IFB ADDENDUM #1

Re: IFB 2024-7 Highland Parkway Electrical Redistribution

This Addendum modifies and forms a part of the Bid Set documents dated April 3, 2024.

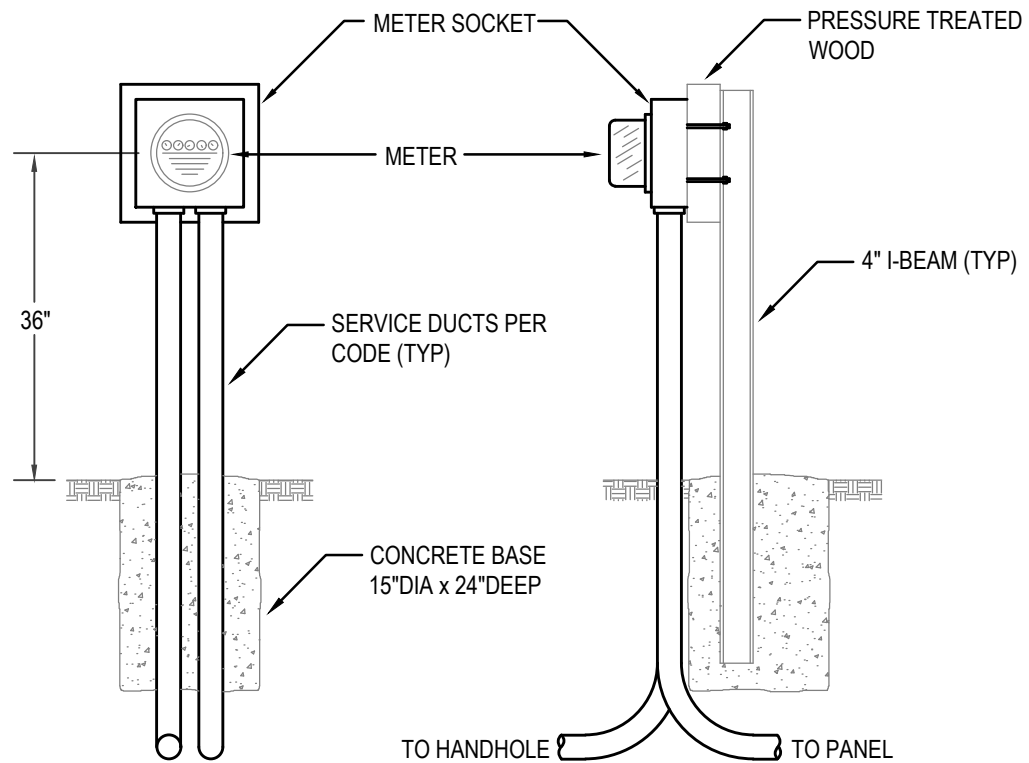
Response: Pre-cast is acceptable. Follow the parameters indicated on the detail provided. No additional detail will be provided.
- 1.11 **Question 11:** Drawing E002 shows a pedestal mount utility meter. Please provide a detail depicting the pedestal material and distance from the transformer pad.

Response: Refer to detail attached.
- 1.12 **Question 12:** Drawing E002 shows a 1 ¼" conduit (8) # 13 between the transformer pad and meter pedestal. This appears to be incorrect. Could you please clarify the intended conductor size and quantity.

1. COMMERCIALY AVAILABLE METER PEDESTALS MAY BE UTILIZED IF APPROVED BY METER DEPARTMENT OF MECO.
2. ENTIRE PEDESTAL INCLUDING METER SOCKET AND SERVICE CONDUCTORS, FURNISHED, OWNED AND MAINTAINED BY CUSTOMER.
3. SERVICE DISCONNECT WITH OVERCURRENT PROTECTION MAY BE REQUIRED.
